SWAN R-LED connector interference

2021/10/1

FFC connector was crooked

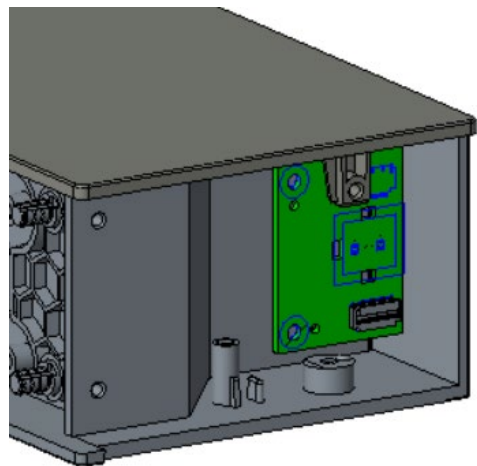
The FFC connector on right side LED PCBA was crooked.

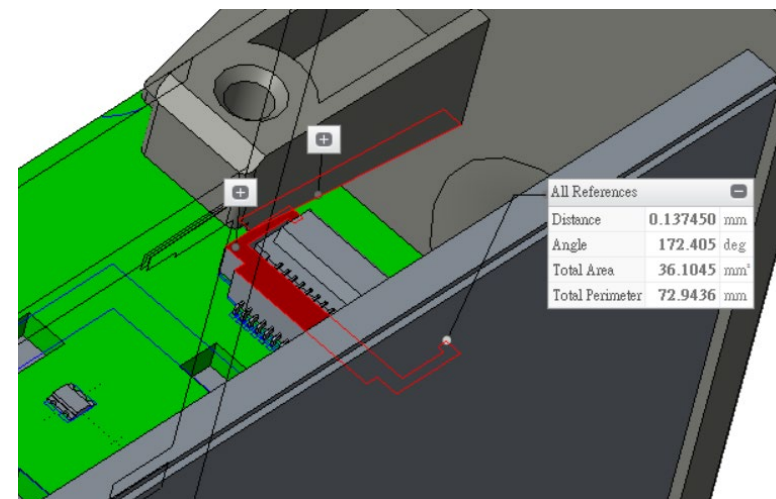
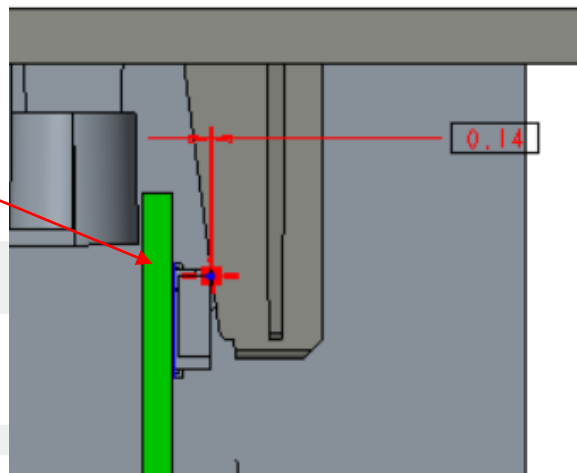
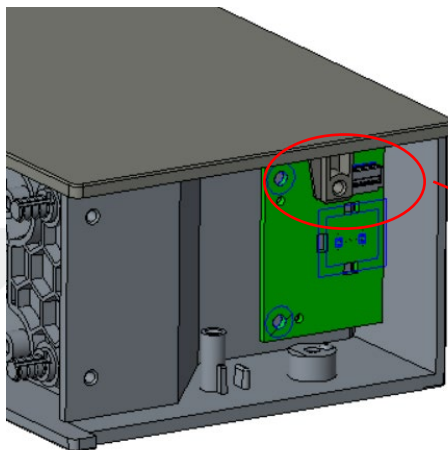
1. Open the defected DUT to analyze the problem. We found out the crooked issue is come from extrusion between the connector and top cover screw boss.
2. RD confirmed that we changed the right side LED PCBA FFC connector from bottom side to top side for the convenience of assembly FFC cable from DVT3. The gap between connector and top cover screw boss is 0.1~0.2mm only.
3. Considering material (housing, connector, PCB)/SMT/assembly tolerance, it's high risk to get interference problem.

Short-term solution - cutting the rib of screw boss

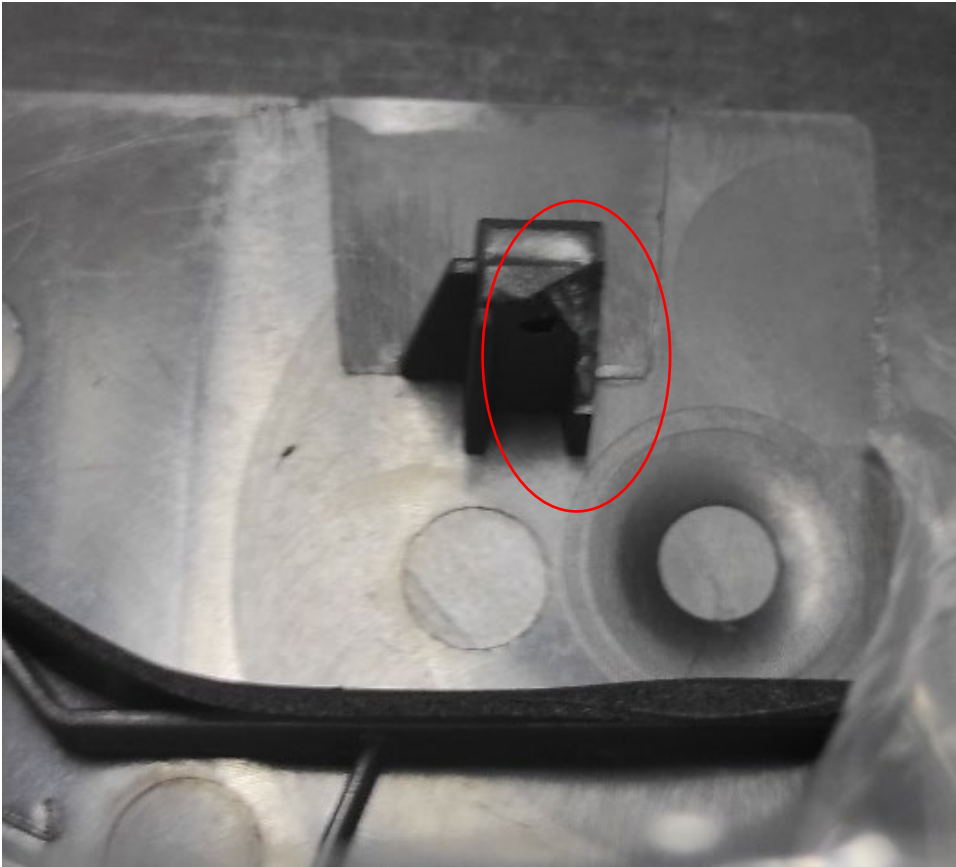
- Factory is cutting the rib to prevent interference issue.

Long-term solution - possibility to re-layout LED PCBA

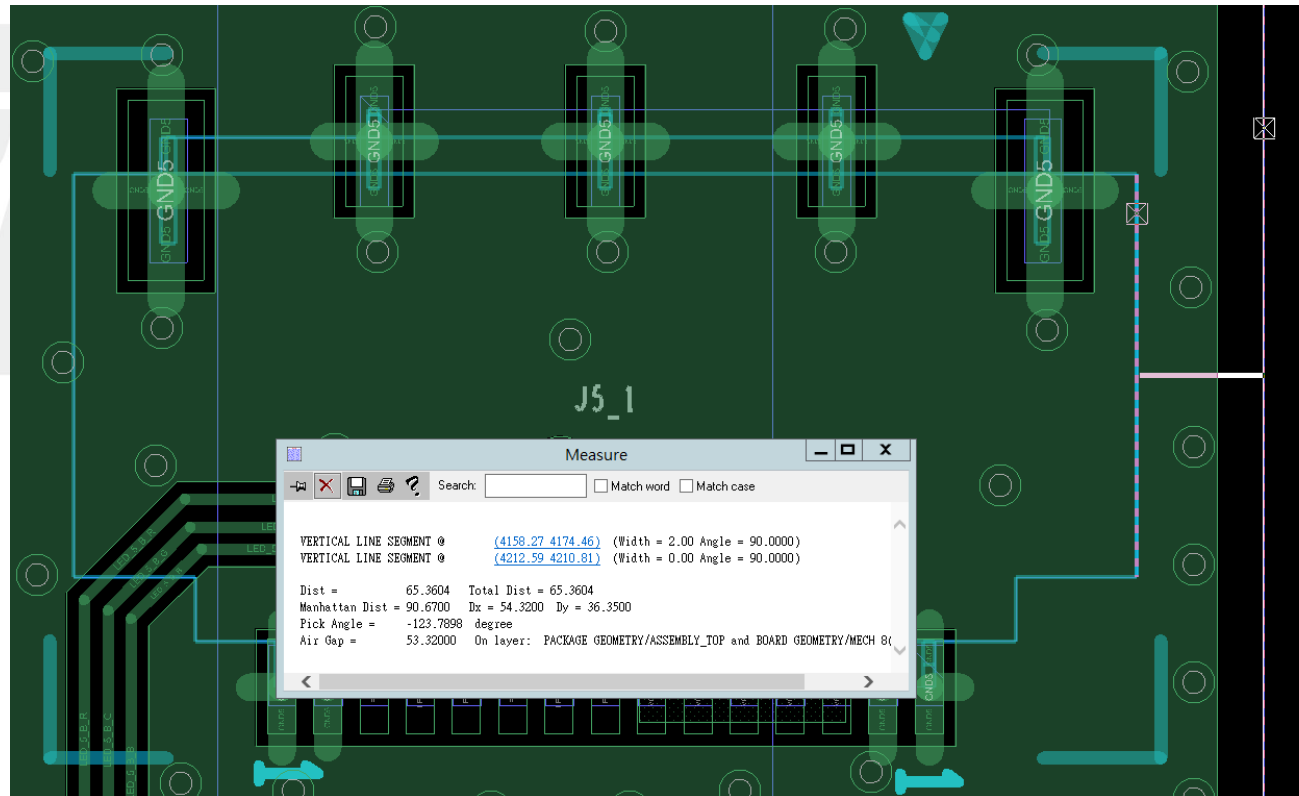
1. The current distance between FFC connector (J5_1) and board edge is 53.2 mil,
2. If Fii to move FFC connector (J5_1), the limitation is right shift 33 mil based on SMT rule (greater than 20 mil).
3. However, the problem cannot be solved by re-layout because factory needs 80mil assemble tolerance between FFC connector and screw boss.
